**AMENDMENTS TO THE DRAWINGS:**

The attached drawing(s) include changes to FIGS. 4 and 5. The sheet containing FIGS. 4 and 5 replaces the original sheet filed as FIGS. 4 and 5.

FIG. 4

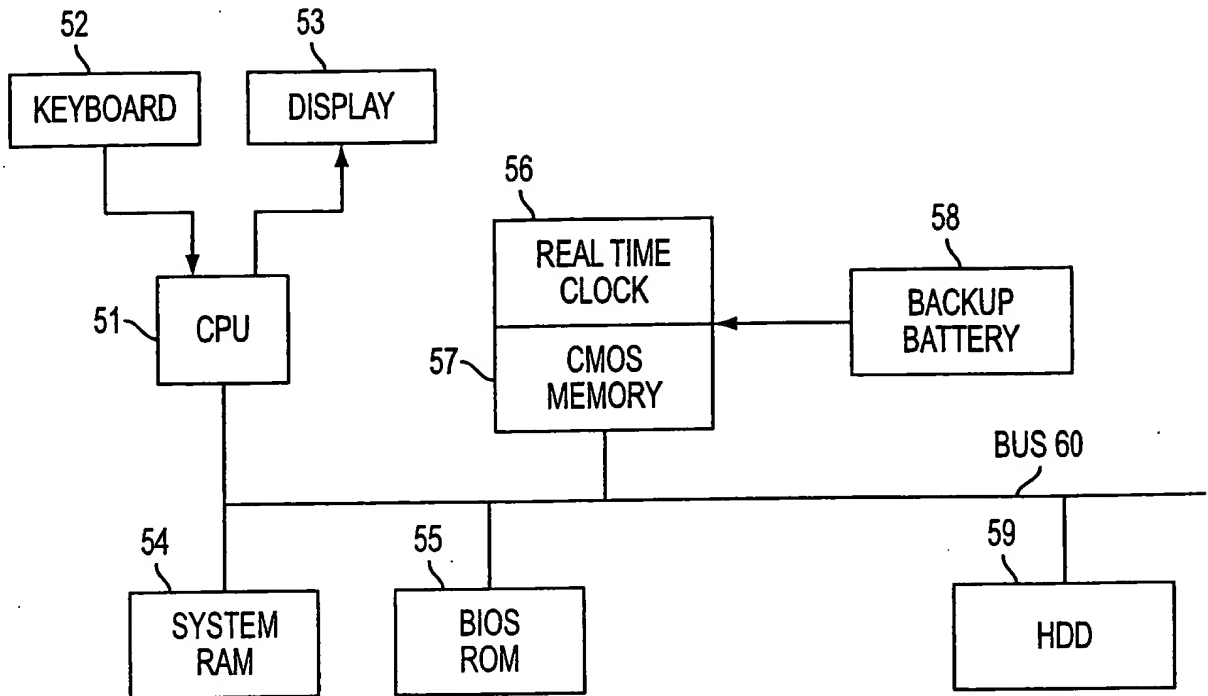
( PRIOR ART )
